BIDDING AND CONTRACT DOCUMENTS
ADDENDUM NUMBER TWO
STATE PROJECT NO. 16-045B-1

DATE: APRIL 28, 2017

CAMDENTON MEMORIAL-LAKE REGIONAL AIRPORT

SUBJECT: ADDENDUM NUMBER TWO TO THE BIDDING DOCUMENTS FOR:
OVERLAY APRON AND PARTIAL PARALLEL TAXIWAY

SHEET 2 OF 24 SHEETS

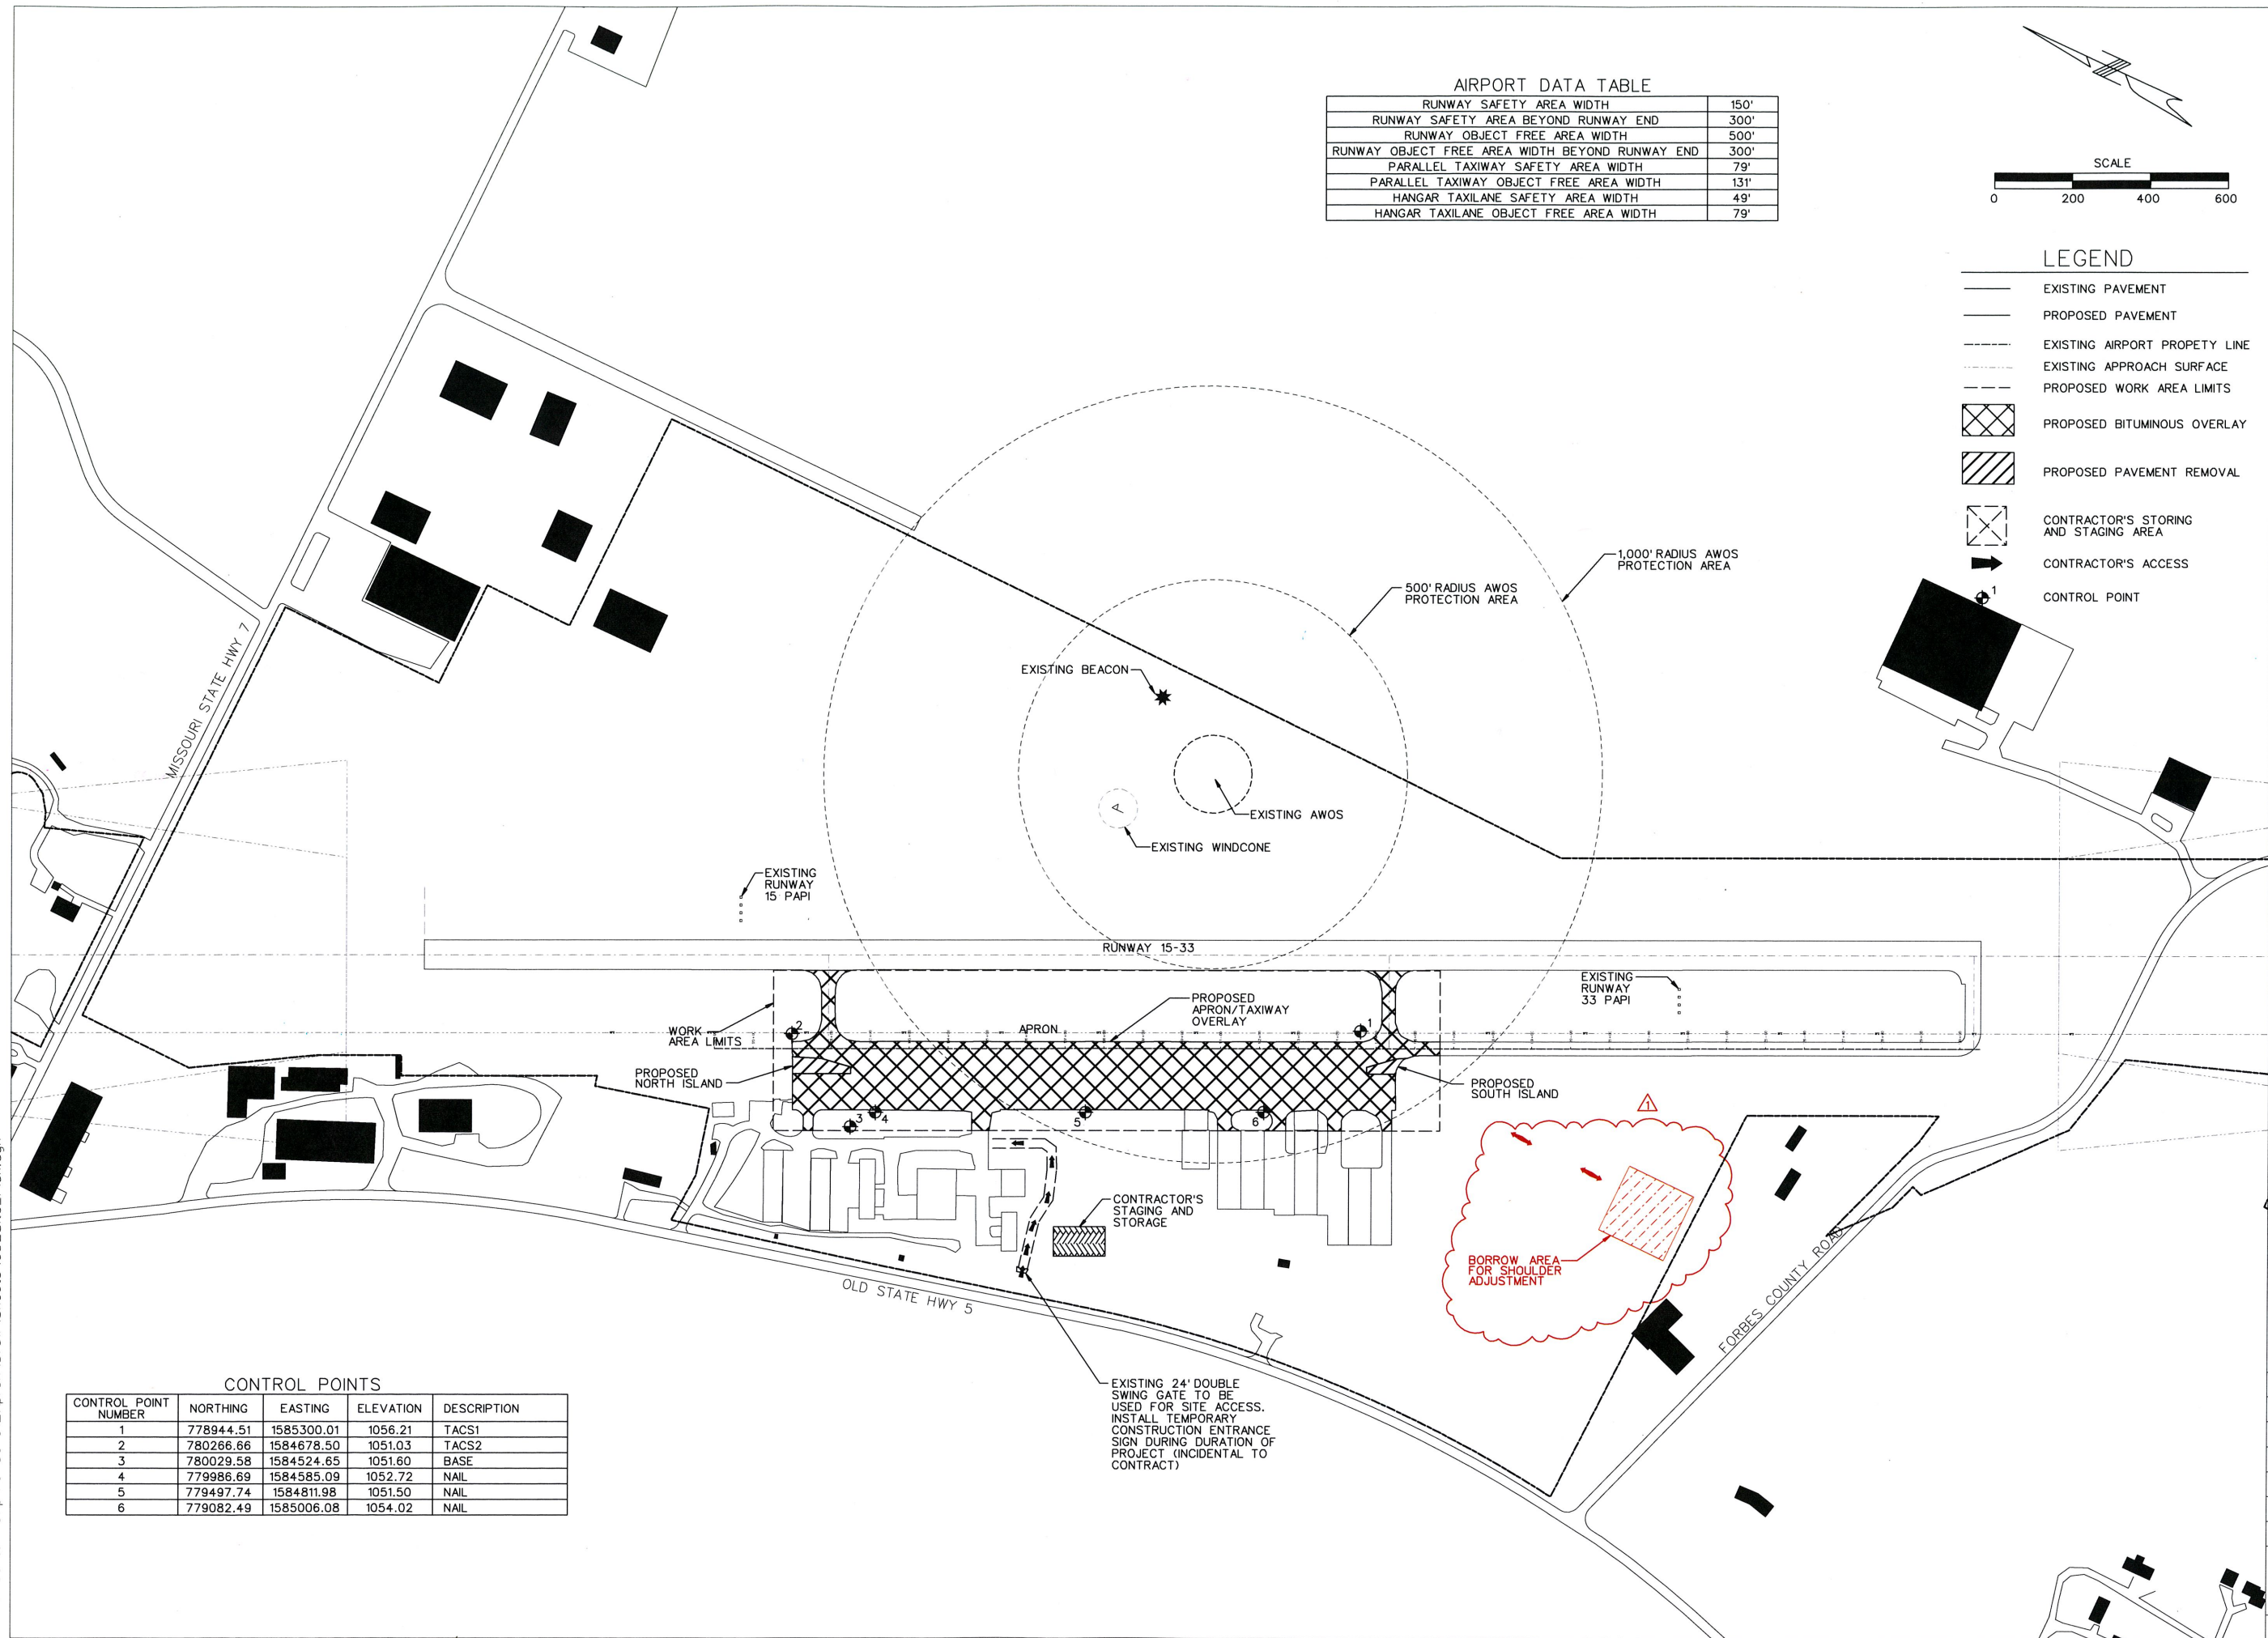
REPLACE Sheet 2 of 24 with REVISION 2.
